TECHNICAL EVALUATION REPORT  
DRESDEN NUCLEAR POWER PLANT UNITS 2 & 3  
INSERVICE INSPECTION PROGRAM

U.S. Nuclear Regulatory Commission  
Fin. B2157

Battelle, Pacific Northwest Laboratory  
Richland, Washington

February 25, 1983

FIGURE 1  
 REACTOR VESSEL WELD IDENTIFICATION

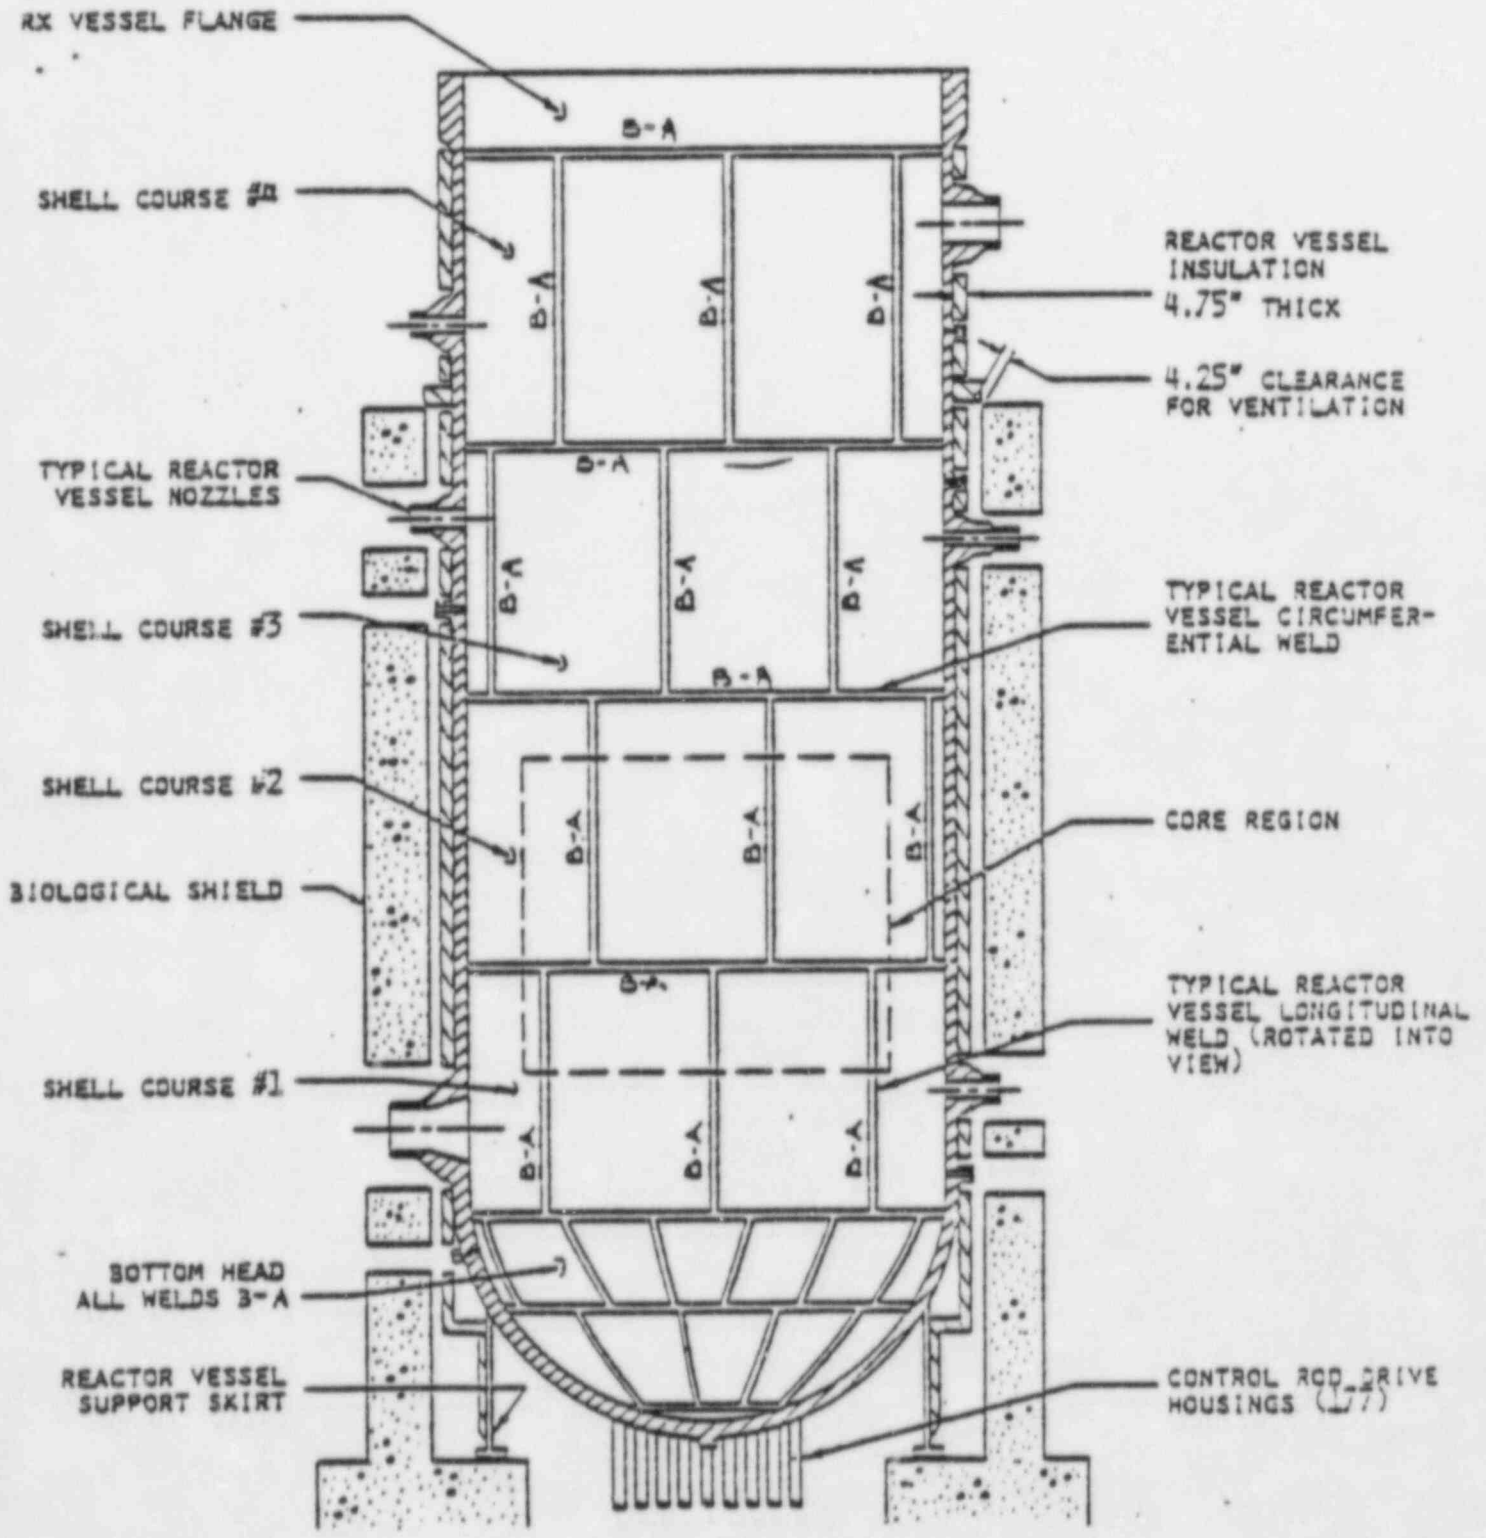
As indicated on Figure 1, examination of the beltline region from the reactor vessel outer surface is precluded due to the close proximity to the biological shield wall and obstruction by the vessel insulation.

The design of the vessel makes these welds physically inaccessible. Imposition of the Code necessitates removal of portions of the biological shield and the permanently installed insulation to perform the required examination. In addition, according to best estimates\* the neutron fluence to the vessel I.D. will be approximately  $1.0 \times 10^{18}$  nvt. at the end of life. Both Units 2 and 3 have ongoing material surveillance programmed which exceed Code requirements. Radiographic examination is also precluded by radiation levels.

Based on the above evaluation, it is concluded that for the subject welds, Code requirements are impractical. It is further concluded that the alternate examination proposed by the licensee will provide the necessary assurance of structural integrity. It is recommended that relief be granted.

Figure 2. Center Section - Hot Fluid Piping Penetration Assembly

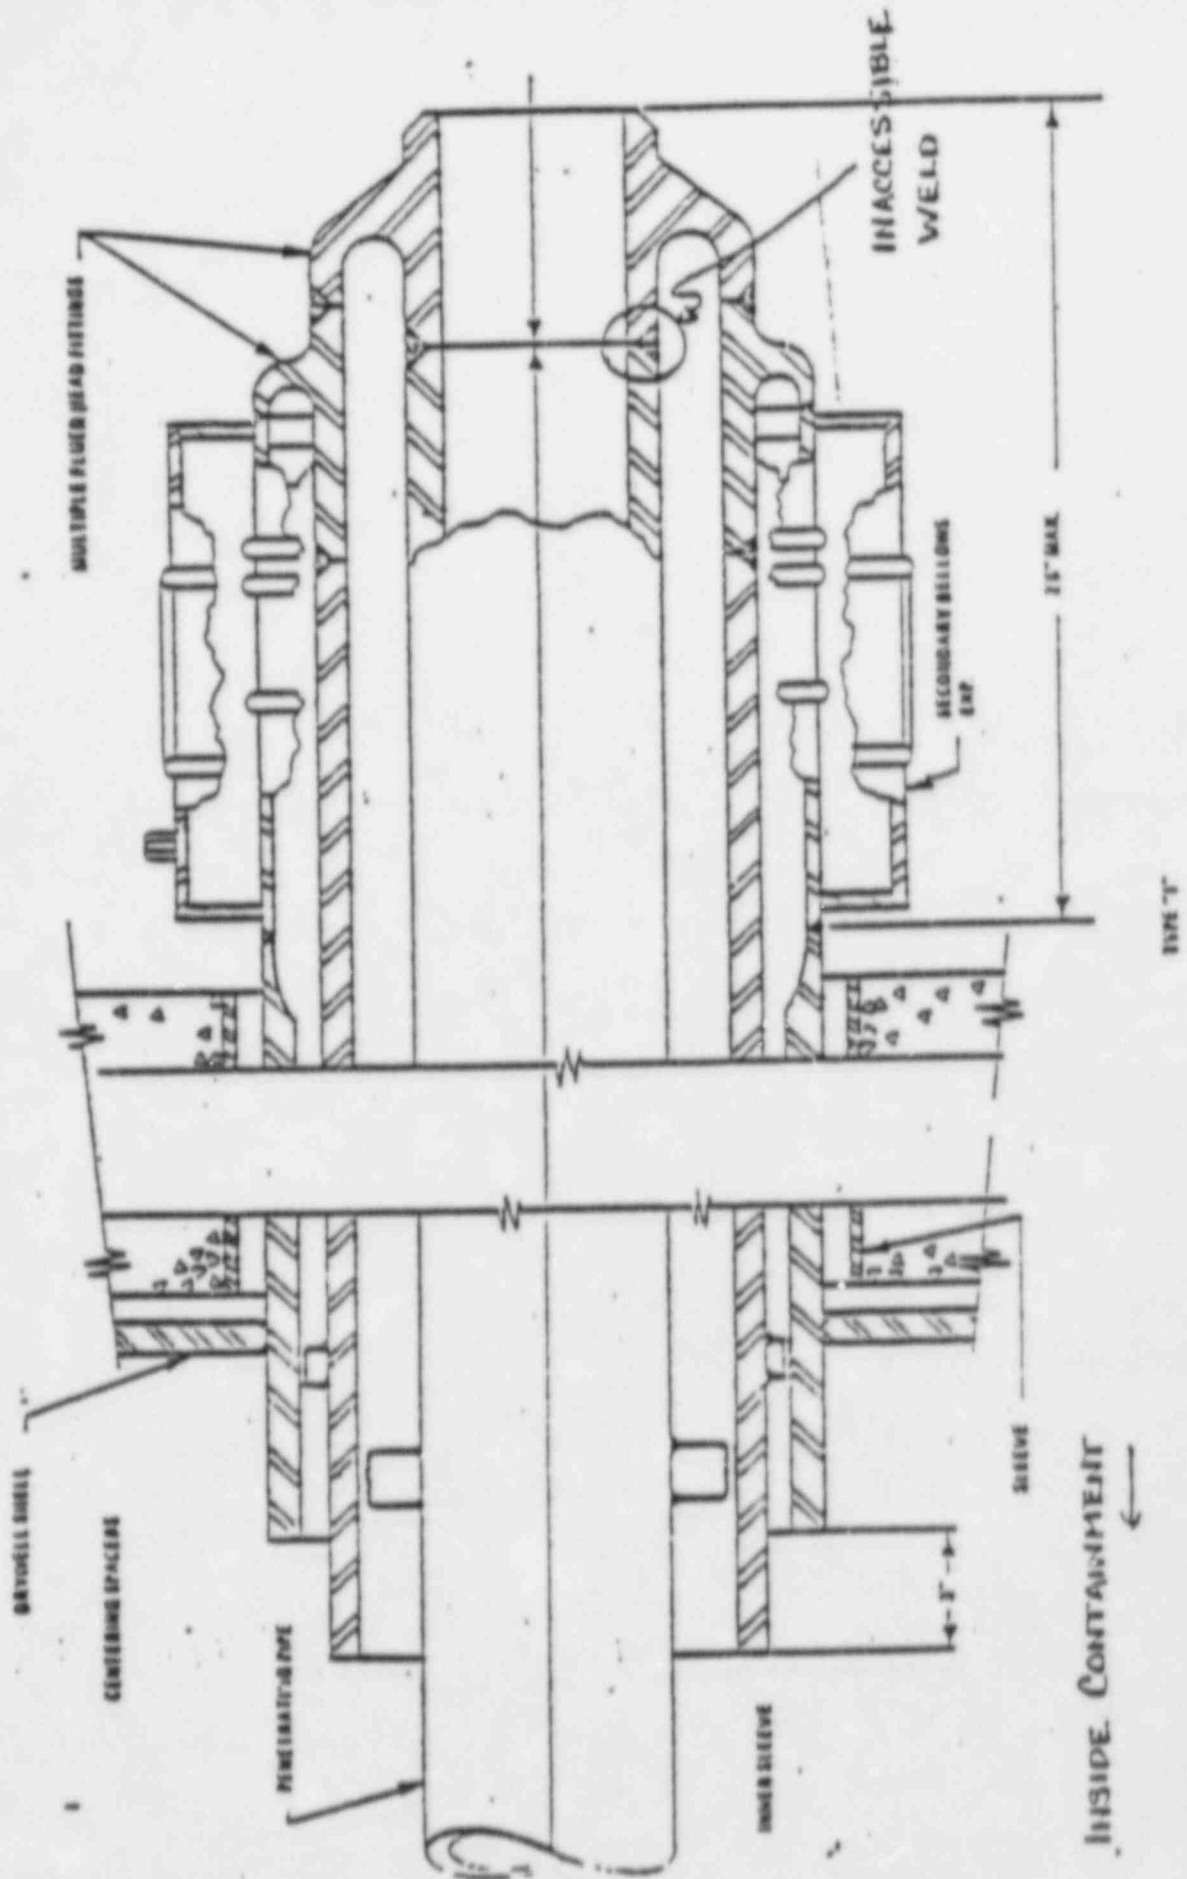
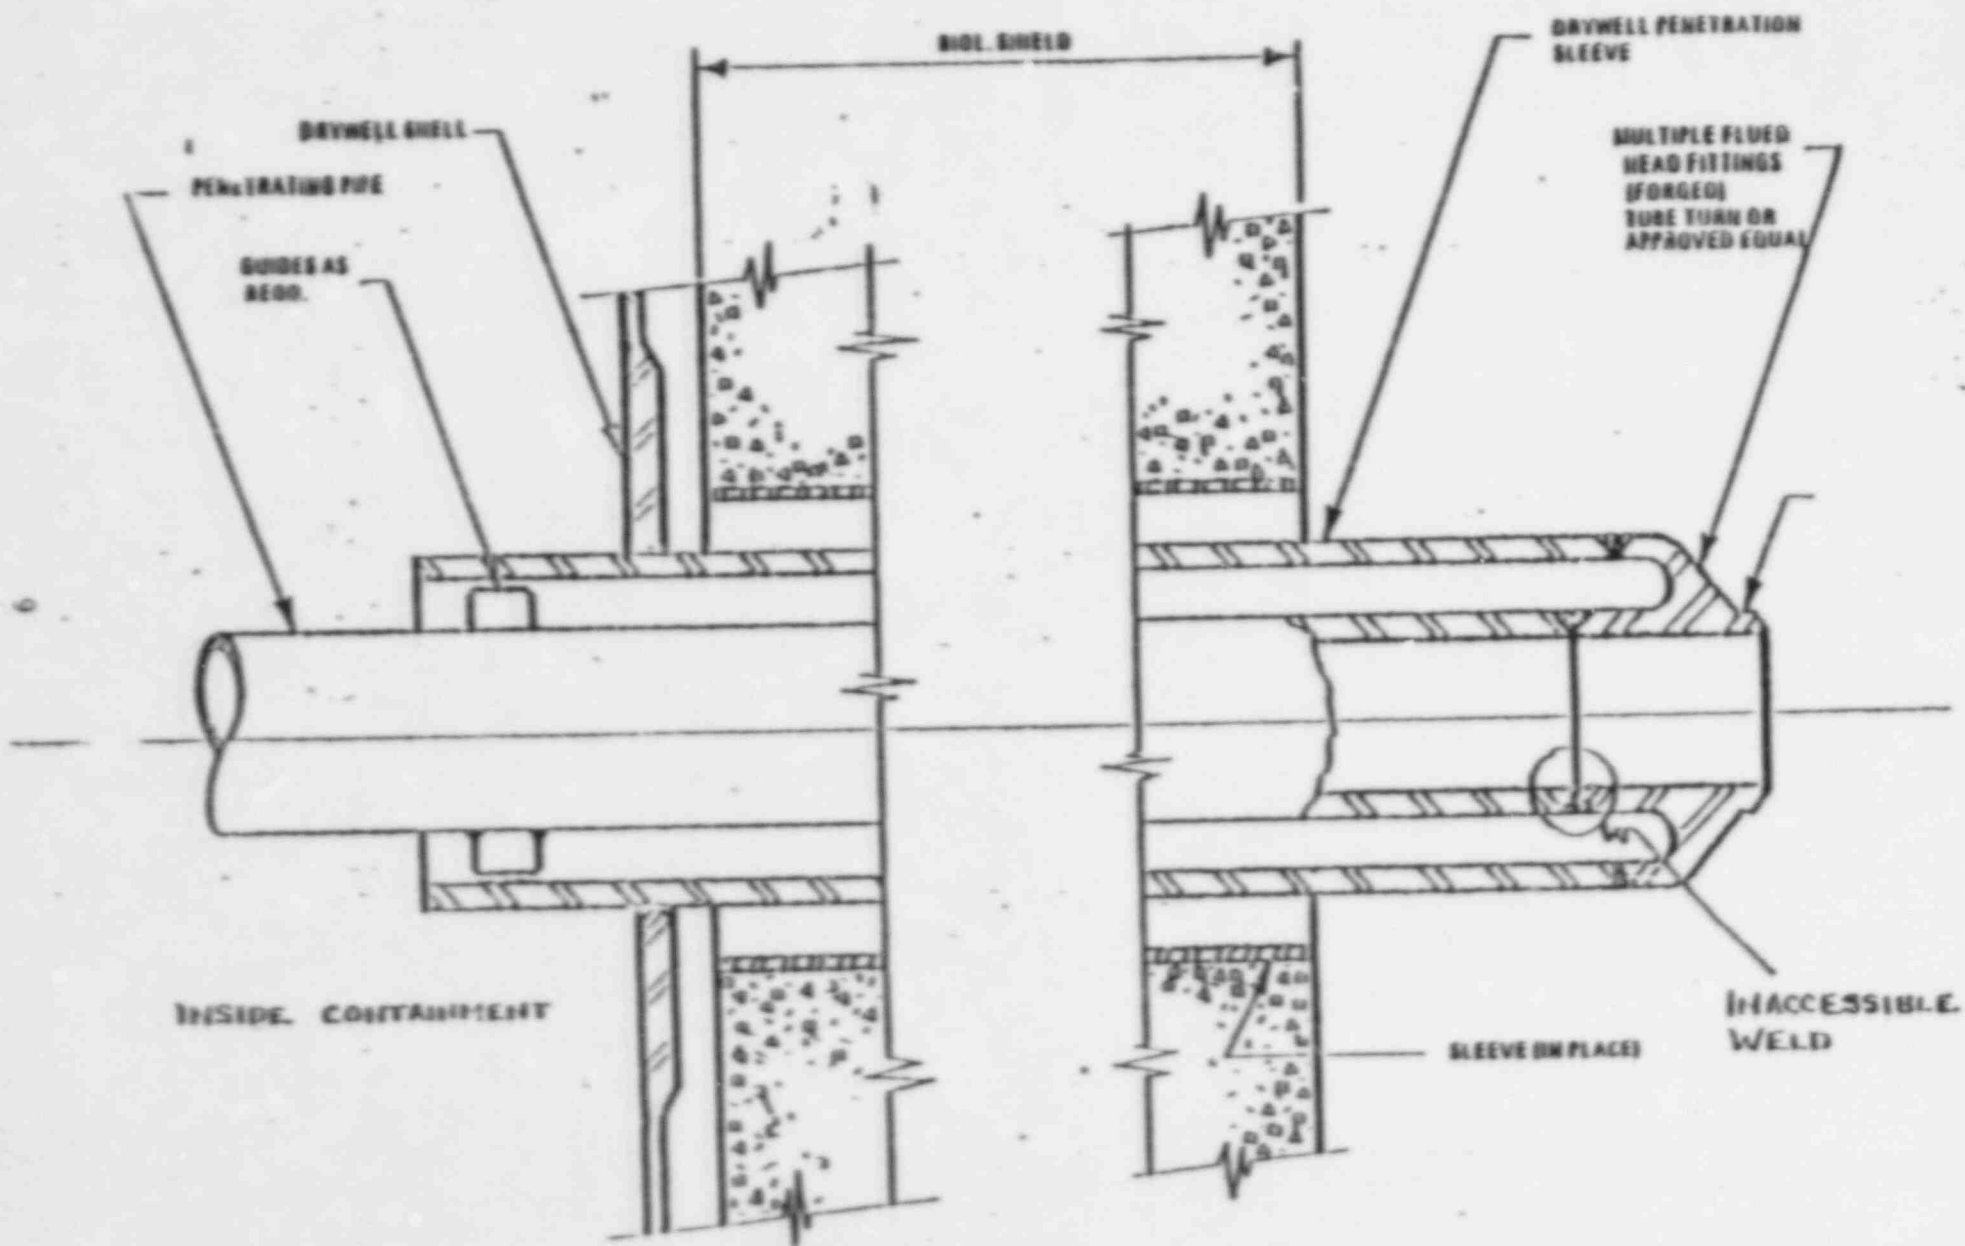
The design of the containment penetrations makes physical access to the welds impossible. We agree with the licensee's basis for relief and alternate inspection program.

Based on the licensee's discussion, Code requirements for the subject welds are impractical. It is recommended that relief be granted.

FIGURE 4

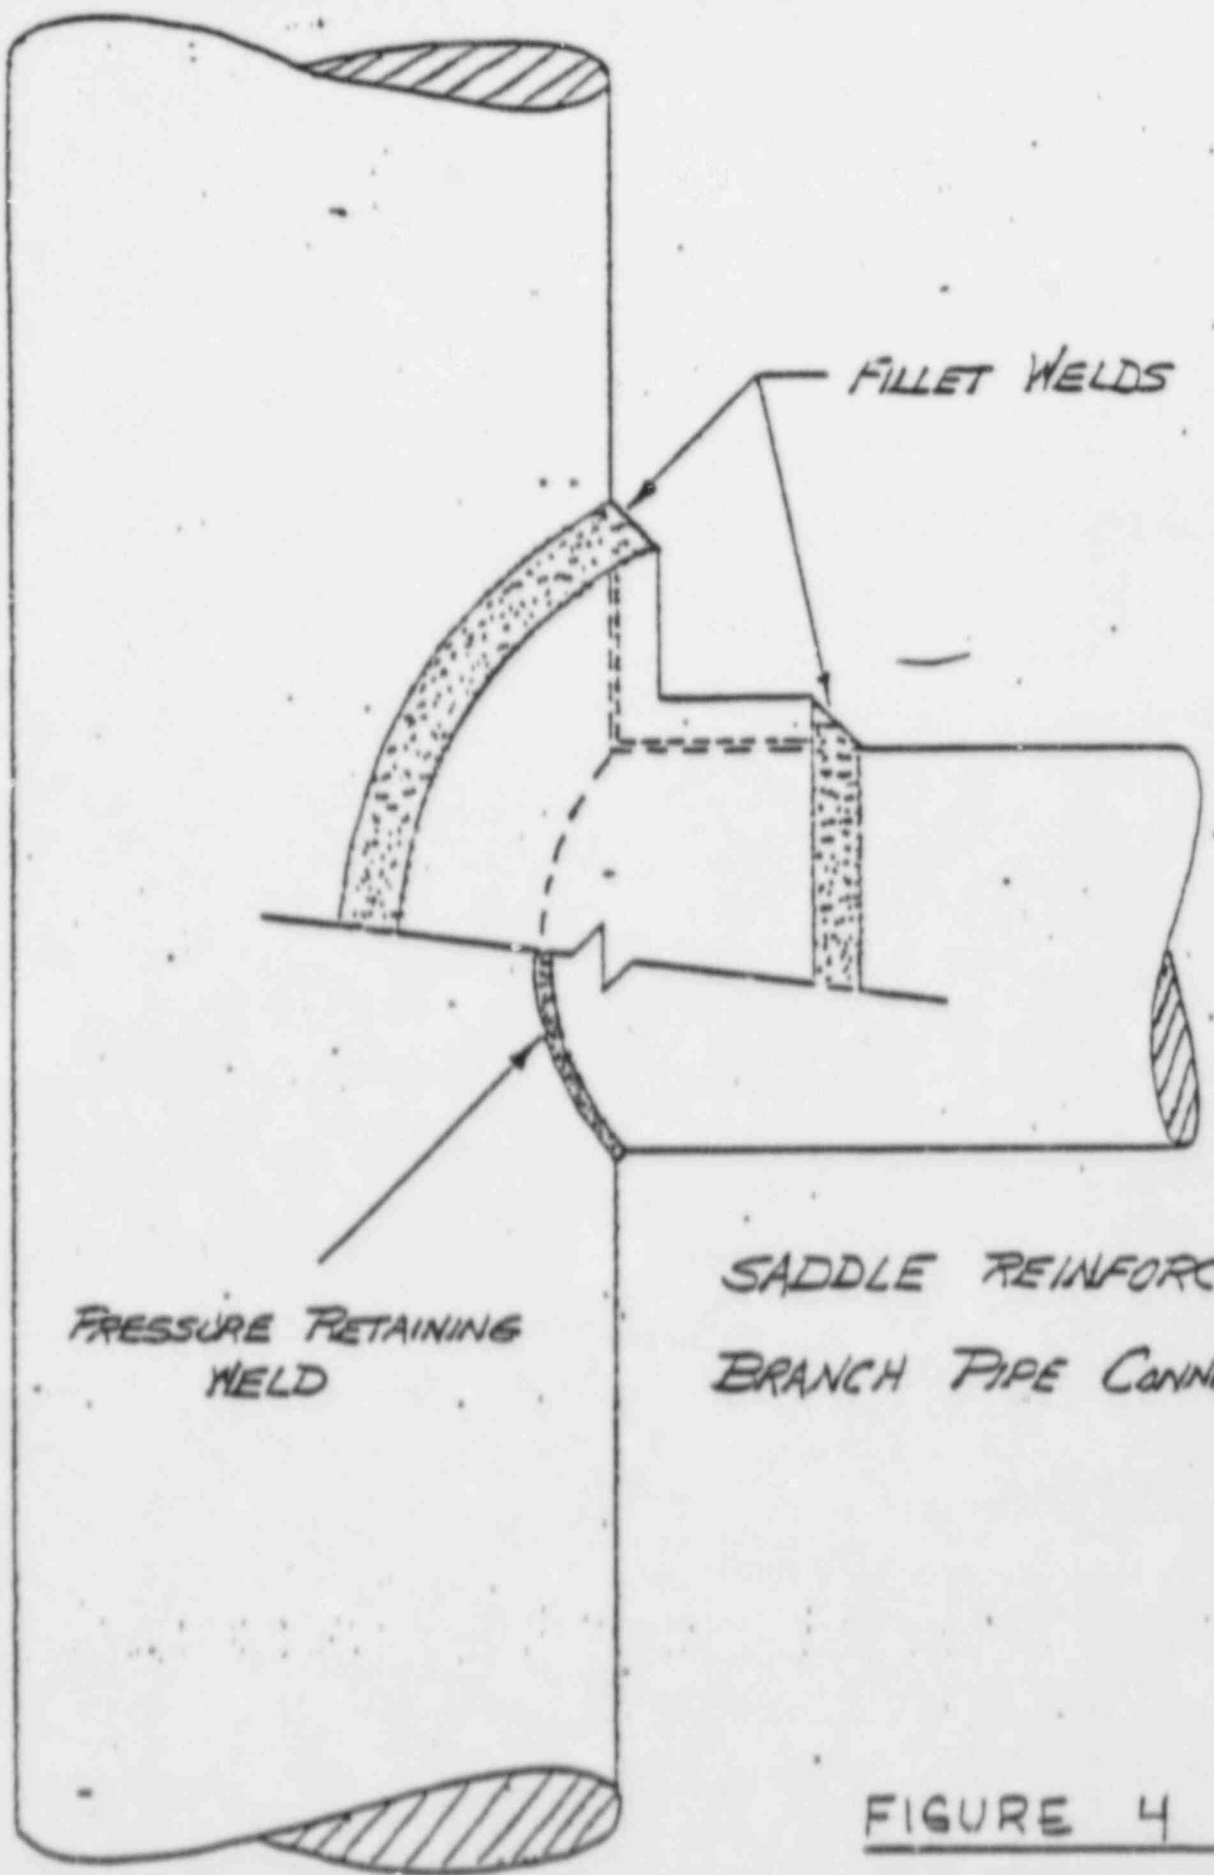
The design of the saddle reinforcement used at Dresden prevents a volumetric examination from being performed on some pipe branch welds. However, the licensee has not provided adequate justification for not performing a surface examination on the fillet welded reinforcement.

The design of the reinforcement saddle prevents ultrasonic examination of the subject welds, but does not limit surface examination from being performed on the saddle fillet weld. It is recommended that relief be granted from Code required ultrasonic examinations and a surface examination of the saddle fillet weld be required.
